ADDENDUM NUMBER 2

Bid 26-24

Bartlett Street Area Reconstruction

Issued February 2, 2024

SHEET: C-405

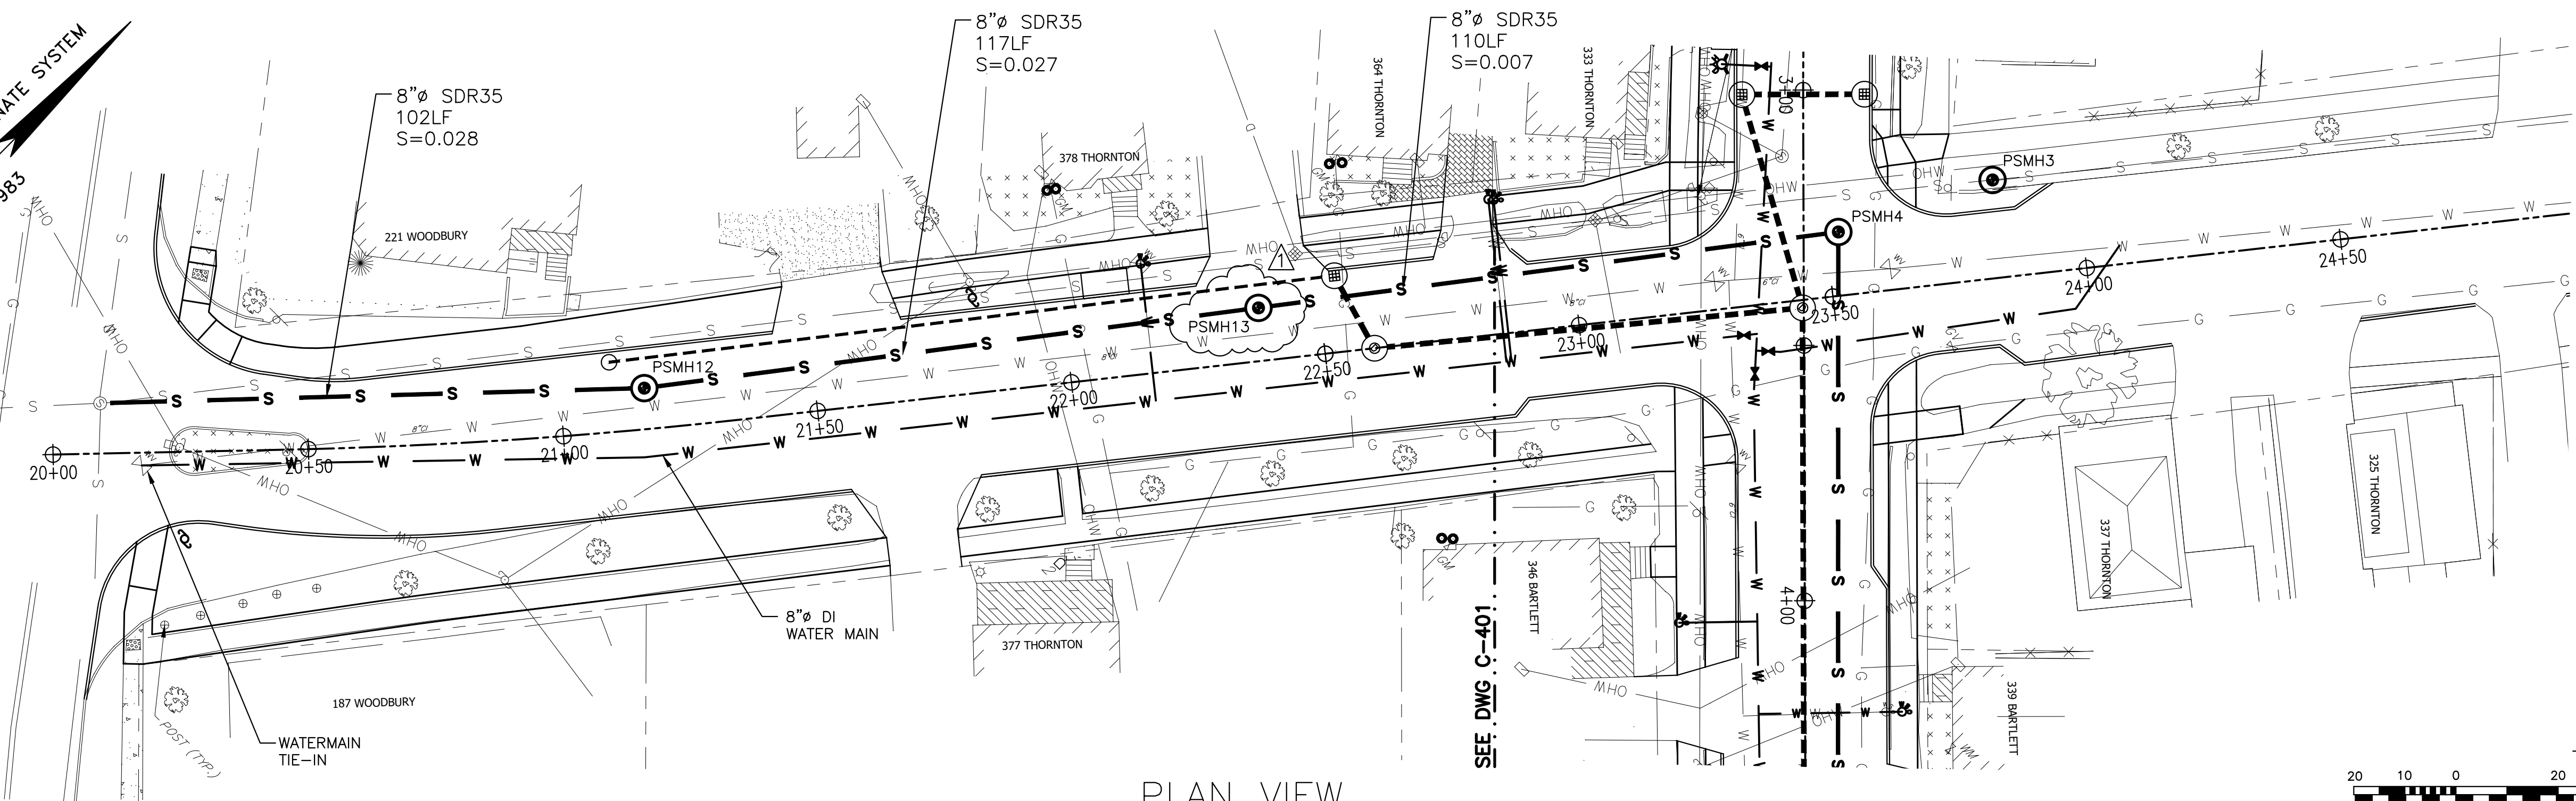
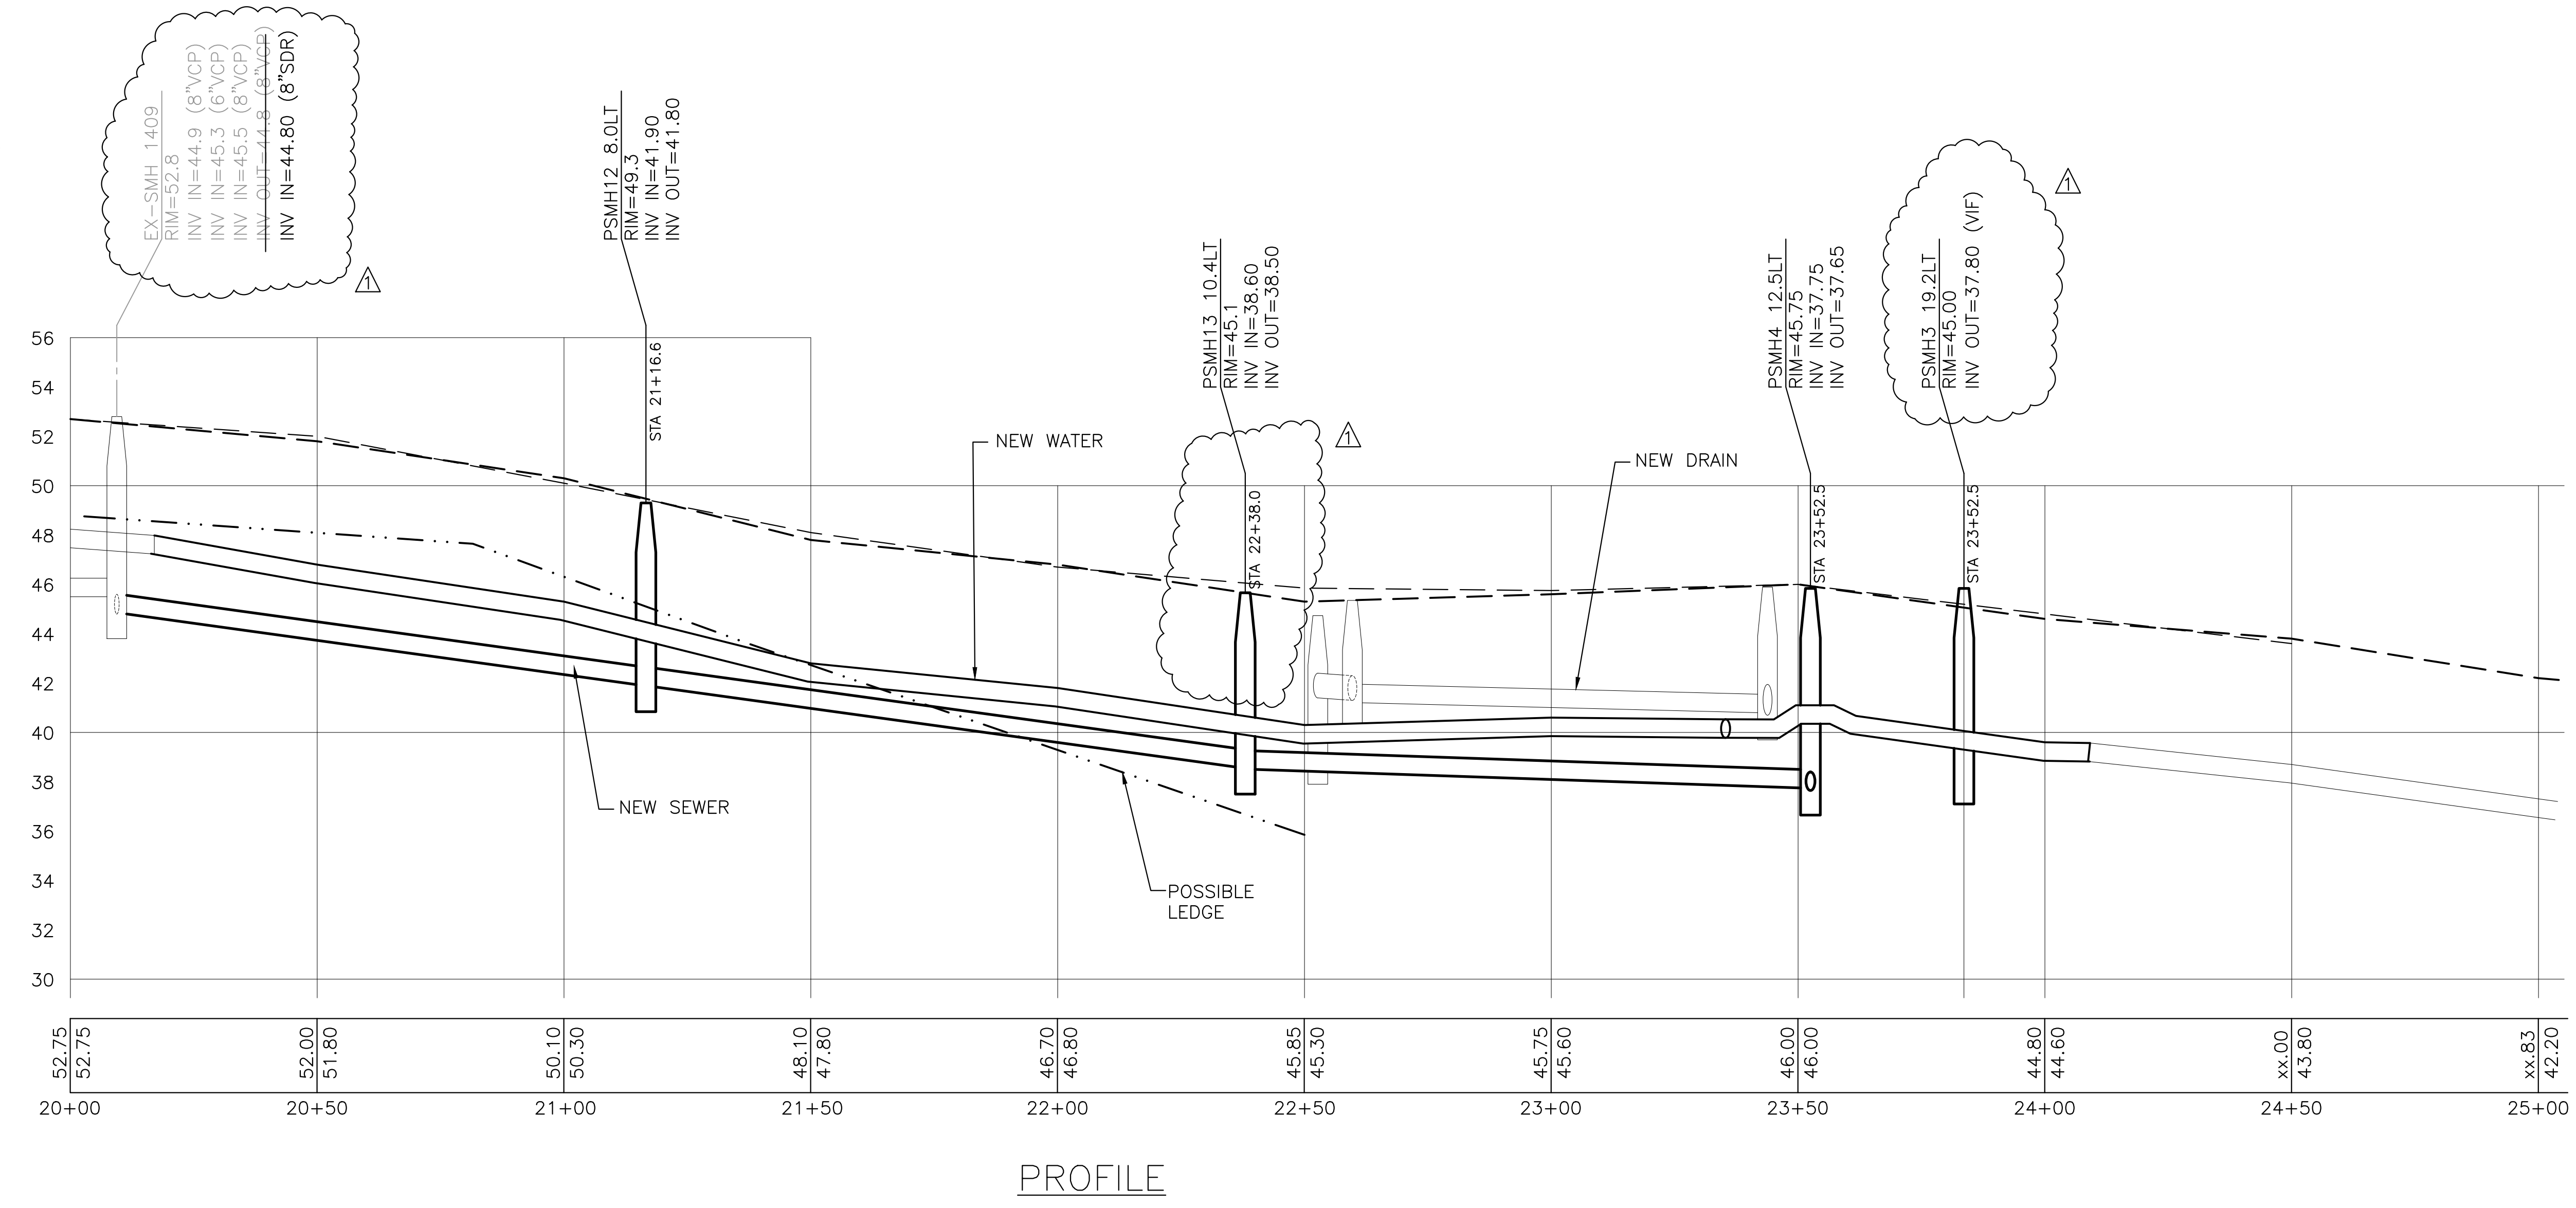
- C-404 - Added note per NHDES request. Clarified core & boot invert information at EX-SMH1397, EX-SMH5530 and EX-SNH5532 per NHDES request.
- C-405 – PSMH13 structure was identified as PSMHxx in Plan View and top of structure was shown as below grade in Profile view, both issues are corrected. Clarified core & boot invert information at EX-SMH1409 per NHDES request. PSMH3 in Profile View included an invert in elevation. There is no invert in on this structure.
